# **CITY OF NEWBURGH GAC TREATMENT SYSTEM AT WASHINGTON LAKE FILTRATION PLANT**

## **ADDENDUM No. 1**

**TO CONTRACT NOS. D010308, D010309, D010310, D010326**

**Arcadis CE, Inc.  
855 Route 146, Suite 210  
Clifton Park, NY 12065**

<b>ARCADIS</b> Design & Consultancy for natural and built assets	CITY OF NEWBURGH		DISCIPLINE	NOVEMBER 2016
	GAC TREATMENT SYSTEM AT WASHINGTON LAKE FILTRATION PLANT		1.2 MG CONTACT TANK 4-20 mA SIGNAL INTERCEPT DETAIL	SK1-I05-ADD1
SCALE:

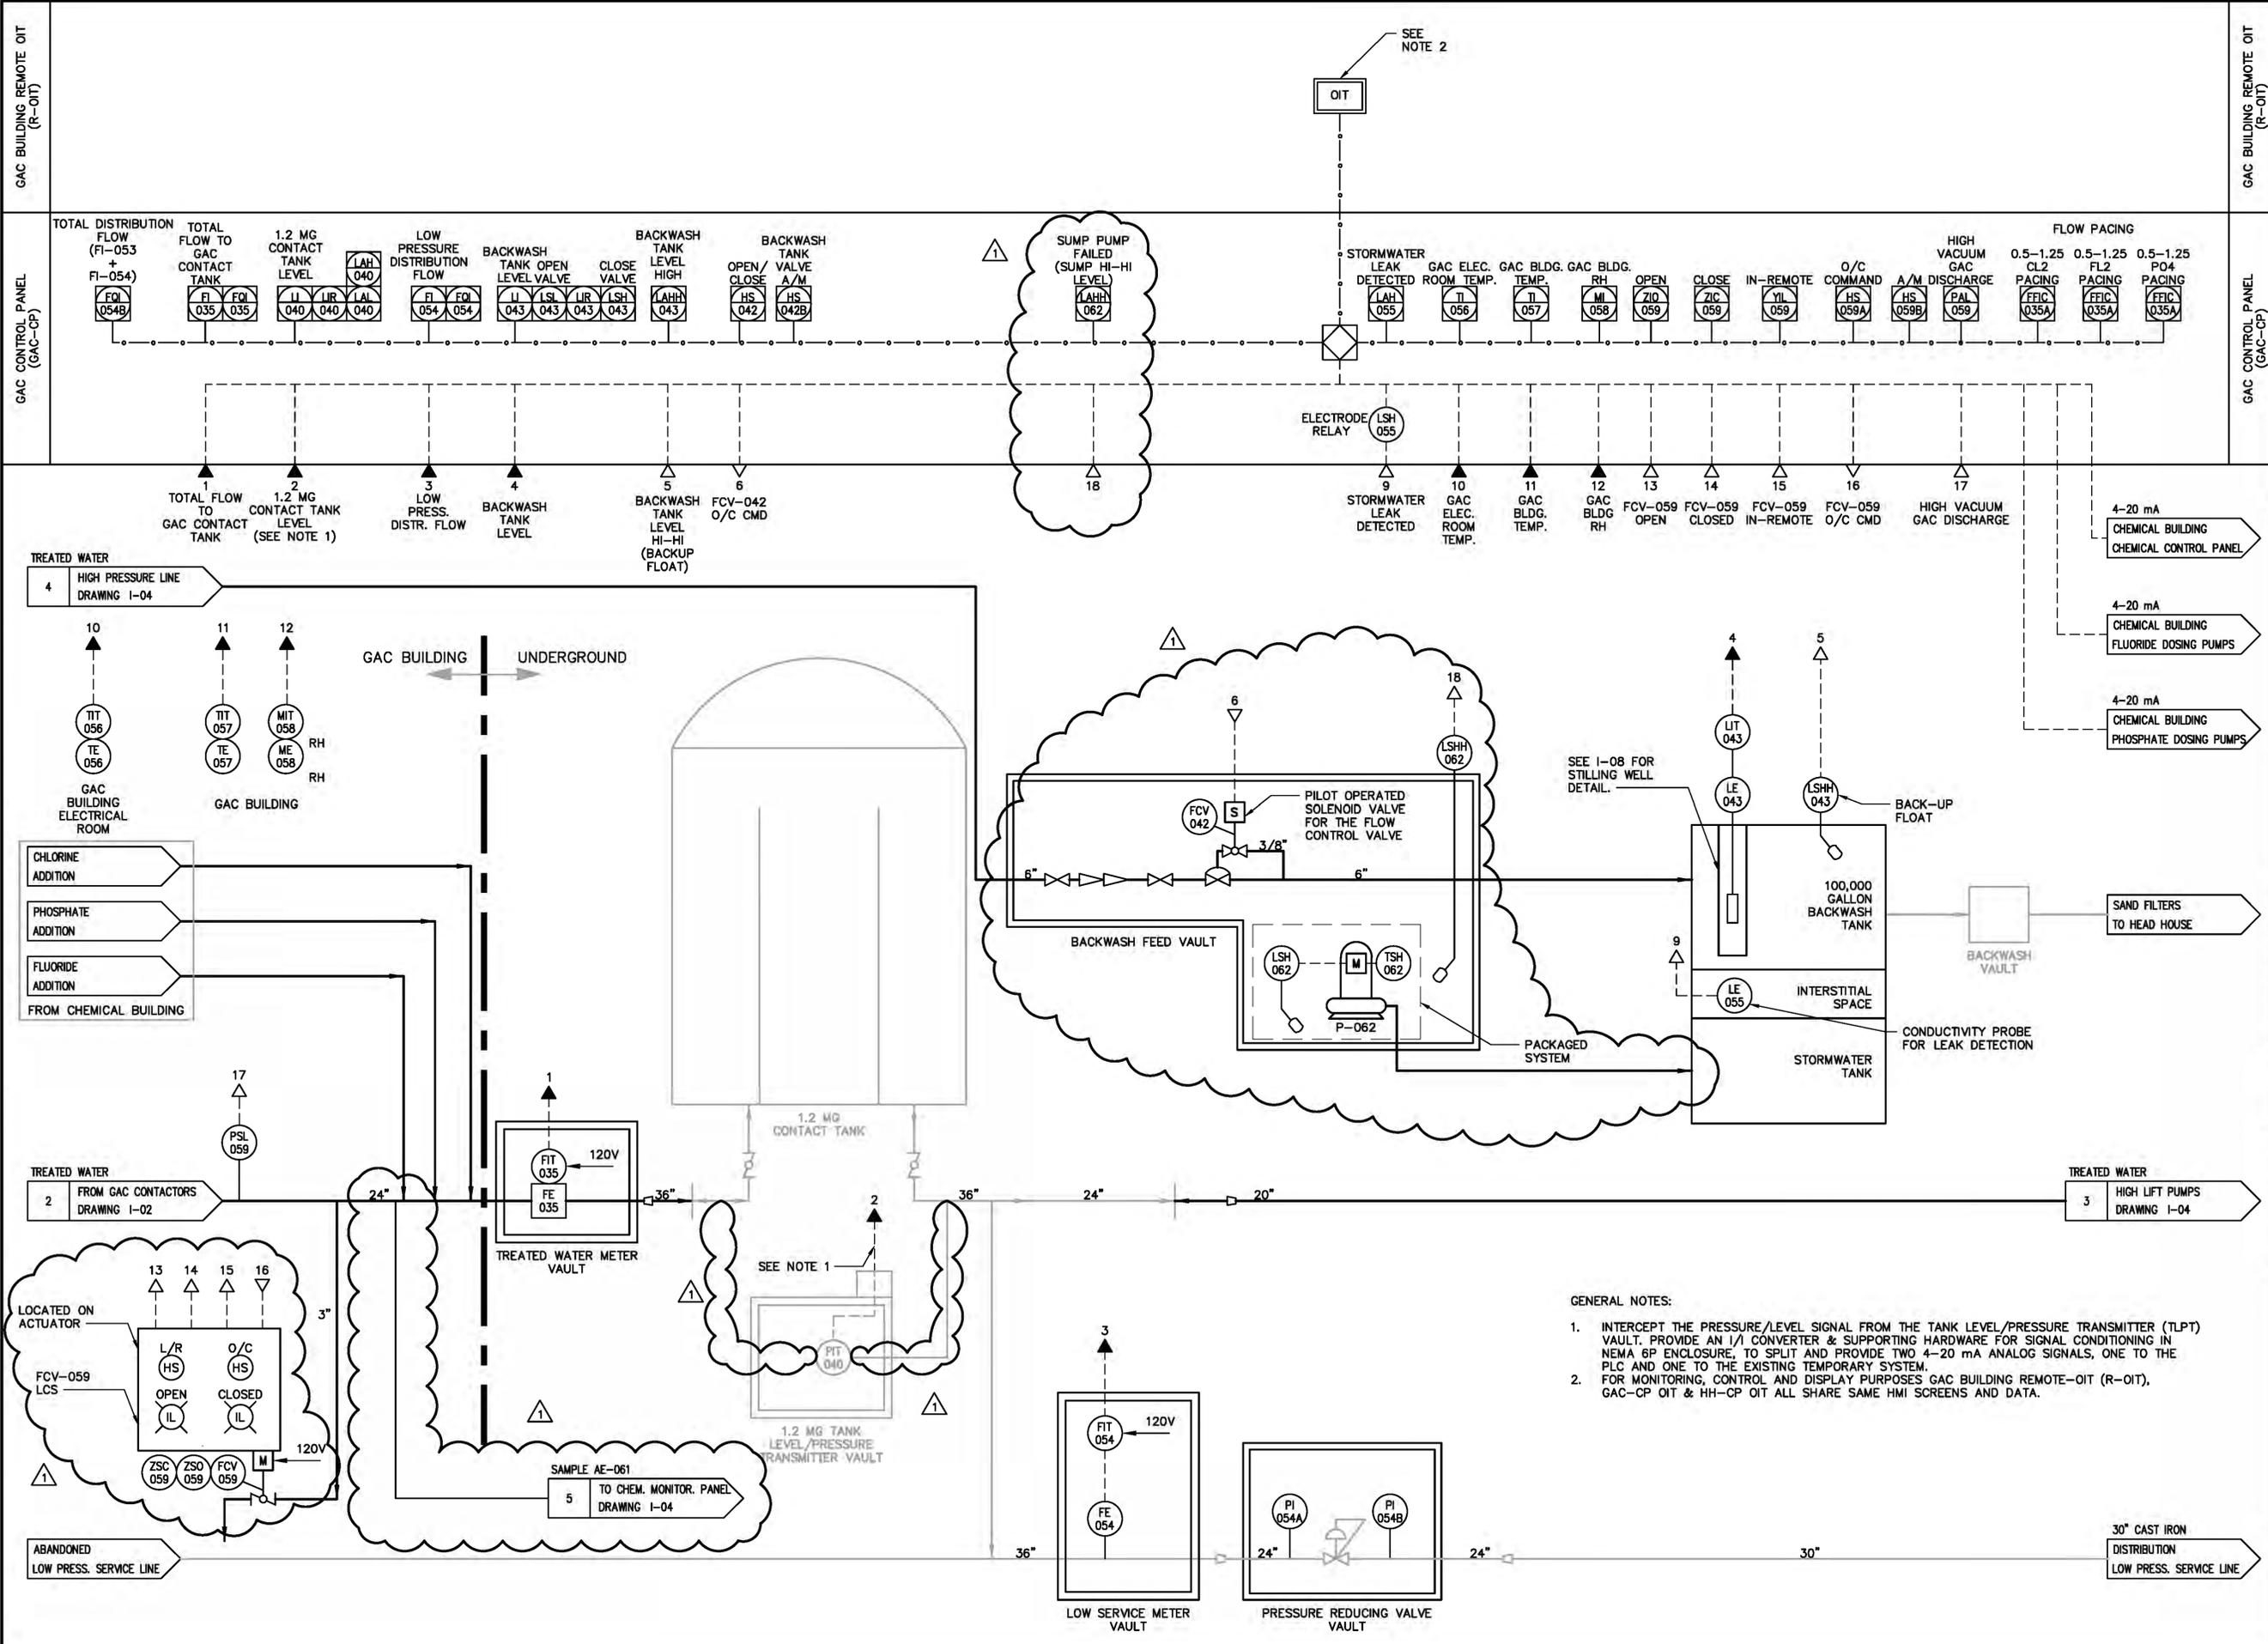
27. **Drawing I-05:** Add revisions as shown on Figure SK1-I05-ADD1 as attached.
28. **Drawing I-03:** Replace Sheet I-03 with the attached.
29. **Drawing I-04:** Replace Sheet I-04 with the attached.

NOVEMBER 2016  
**SK1-G04-ADD1**

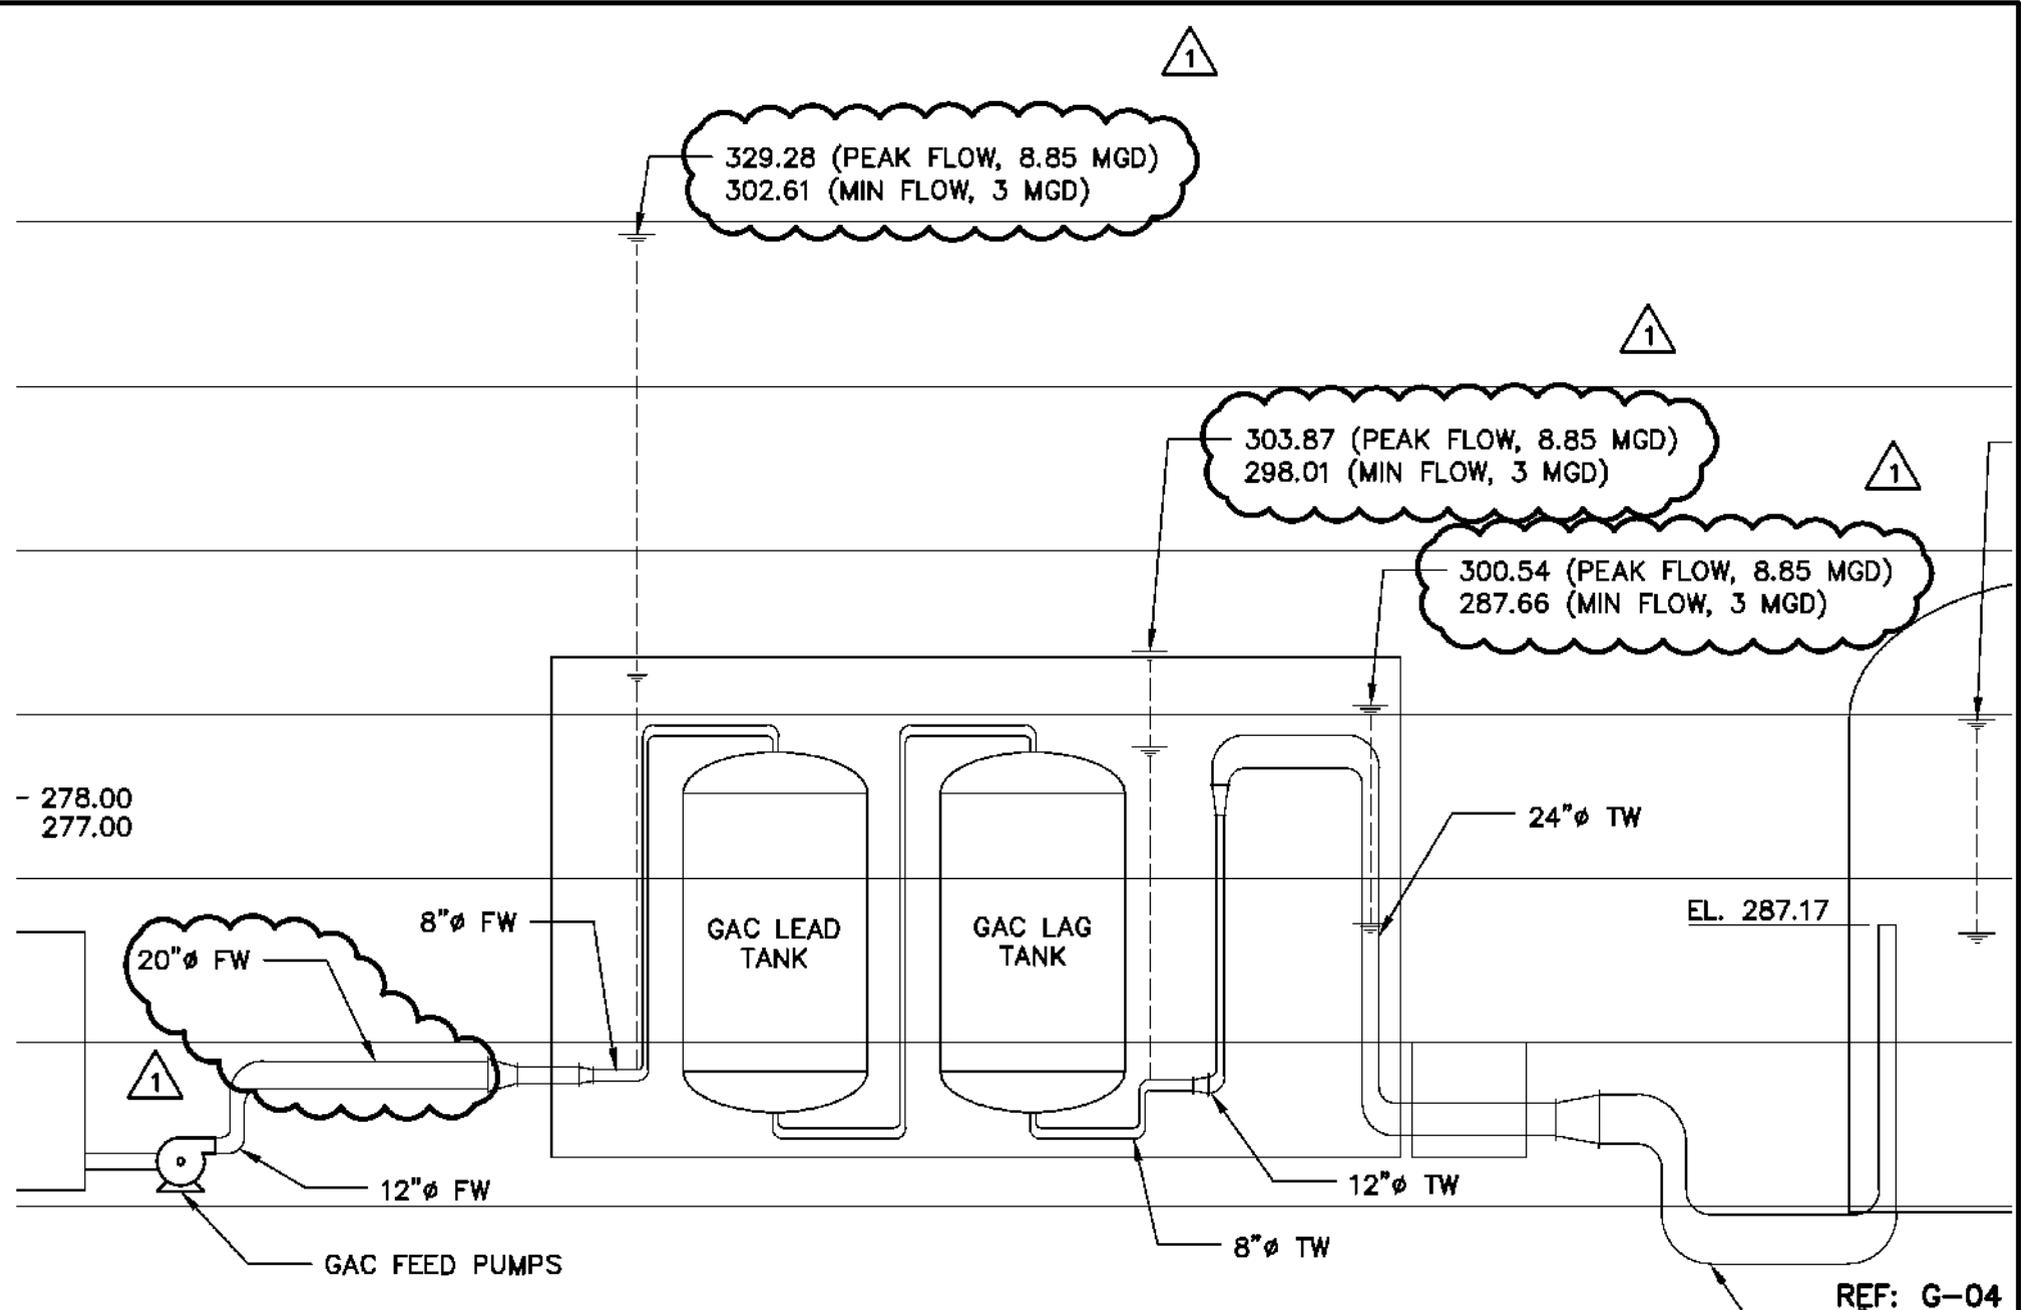
30. **Drawing I-06:** Replace Sheet I-06 with the attached.
31. **Drawing I-09:** Replace Sheet I-09 with the attached.
32. **Drawing G-04:** Add revisions as shown on Figure SK1-G04-ADD1 as attached.

**SK2-G04-ADD1**

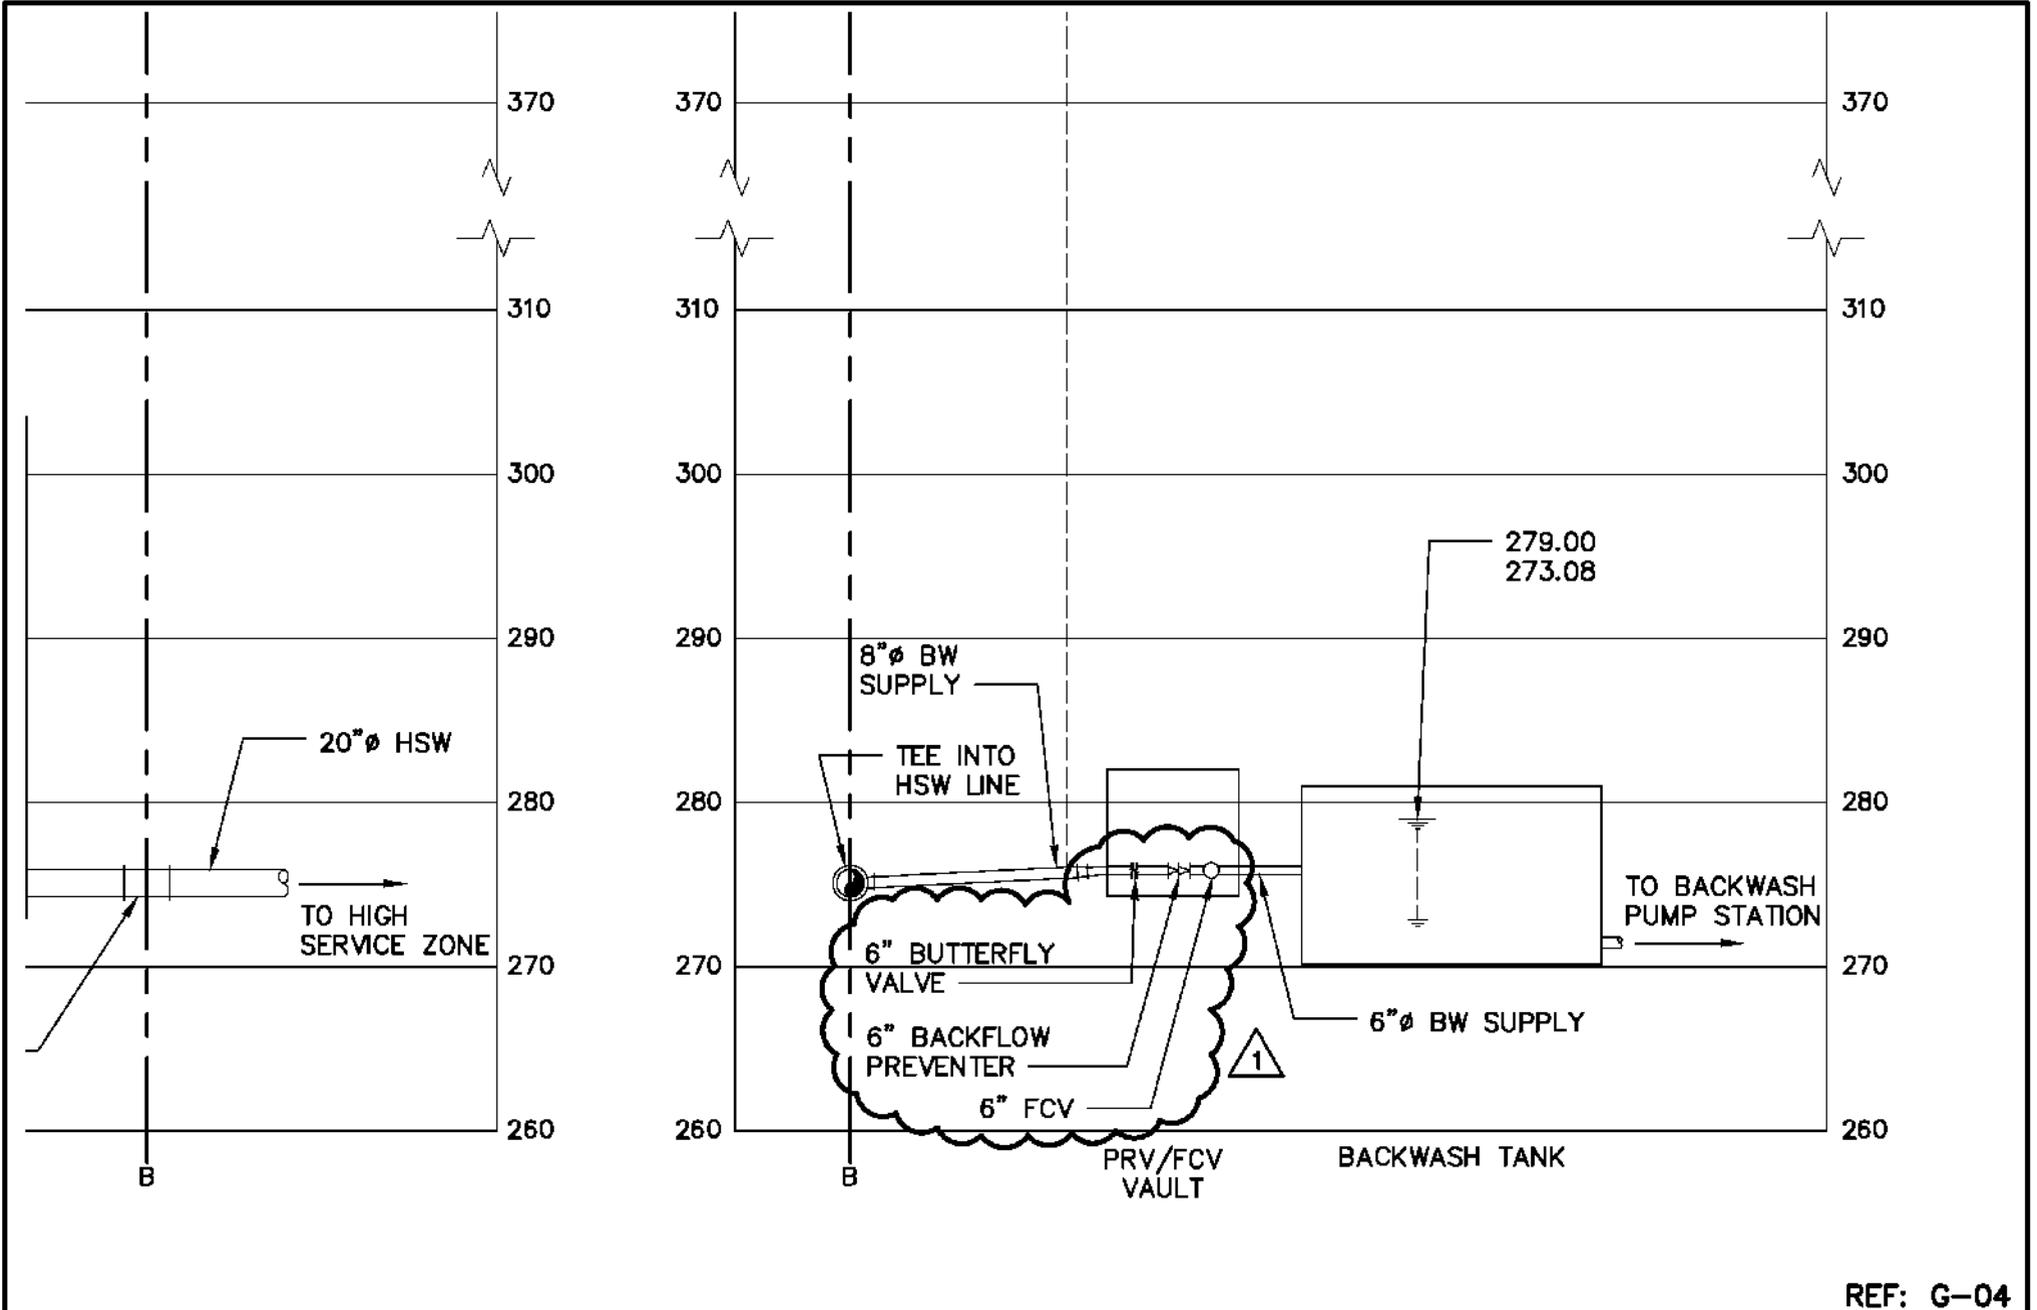
33. **Drawing G-04:** Add revisions as shown on Figure SK2-G04-ADD1 as attached.
34. **Drawing G-04:** Add revisions as shown on Figure SK3-G04-ADD1 as attached.
